<b>AMENDMENT OF SOLICITATION/MODIFICATION OF CONTRACT</b>				1. CONTRACT ID CODE	PAGE 1 OF 3 PAGES
2. AMENDMENT/MODIFICATION NO. AMENDMENT NO. 0001		3. EFFECTIVE DATE 8/12/11	4. REQUISITION/PURCHASE REQ. NO.	5. PROJECT NO. (If applicable) 11-0086	
6. ISSUED BY CODE sdb  Officer in Charge of Construction MCI-East 1005 Michael Road Camp Lejeune, NC 28547-2521			7. ADMINISTERED BY (If other than Item 6) CODE  See Item 6		
8. NAME AND ADDRESS OF CONTRACTOR (No., street, county, State and ZIP Code)				(X)	9A. AMENDMENT OF SOLICITATION NO.  N40085-11-R-0086
				X	9B. DATED (SEE ITEM 11) 8-12-11
CODE _____ FACILITY CODE _____					10A. MODIFICATION OF CONTRACT/ORDER NO.
					10B. DATED (SEE ITEM 11)

N40085-11-R-0086, Project # 11-0086, McHugh & Seth Williams Road Paving

MCB CAMP LEJEUNE, NORTH CAROLINA  
McHUGH & SETH WILLIAMS RD PAVING  
MARINE CORPS BASE CAMP LEJEUNE  
ENLARGED SITE PLAN  
CONSTR. CONTR. NO. N40085-11-B-0086

1  
SK-1SK-1  
CONCRETE CURB AND GUTTER  
NOT TO SCALE

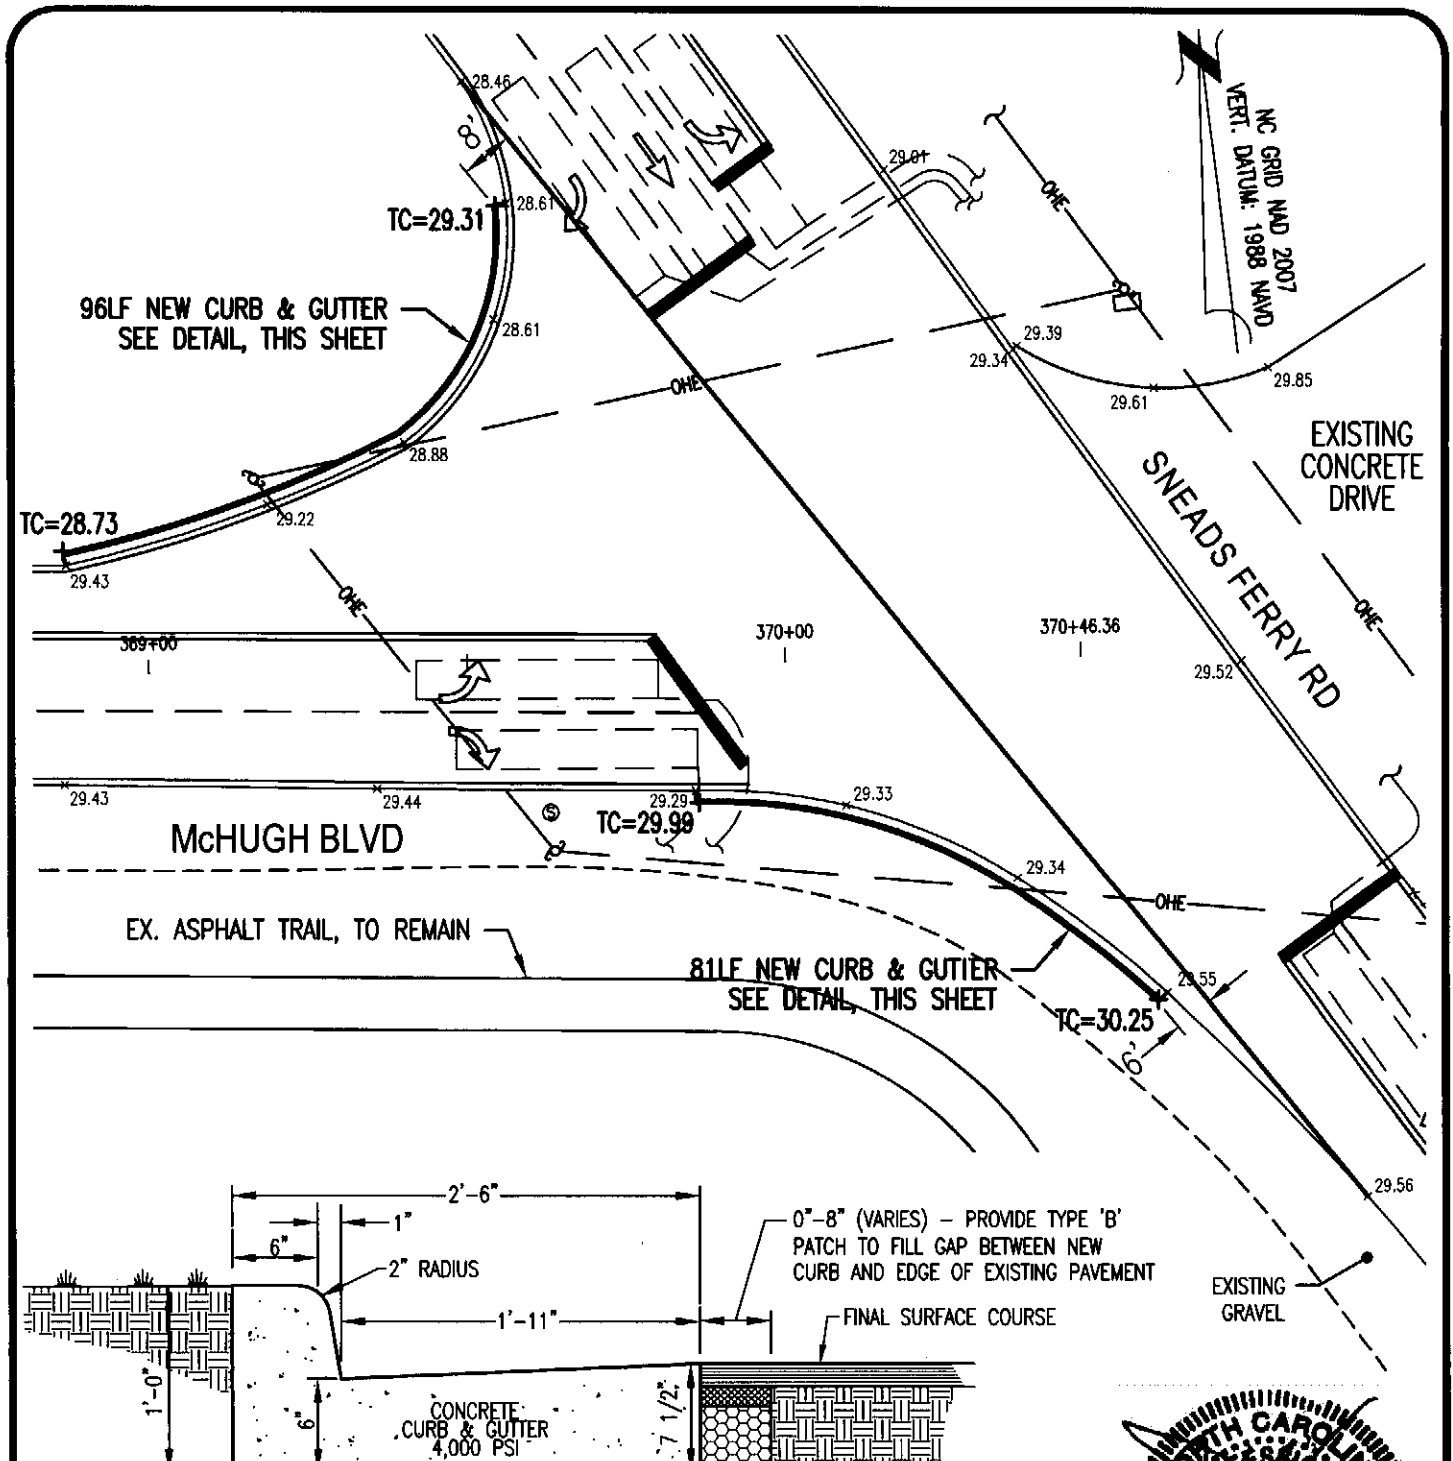
1. Curbs and gutters shall be provided at the intersection of McHugh and Sneads Ferry as indicated in the attached sketch SK-1.
2. Asphaltic concrete surface course in specification Section 02 50 00, Paragraph 2.4 "Asphaltic Concrete Surface Course" shall read "S-9.5B" in lieu of "SF-9.5A."
3. As noted on Sheet C-1, work shall begin at STA. 0+00, Autumn Circle.
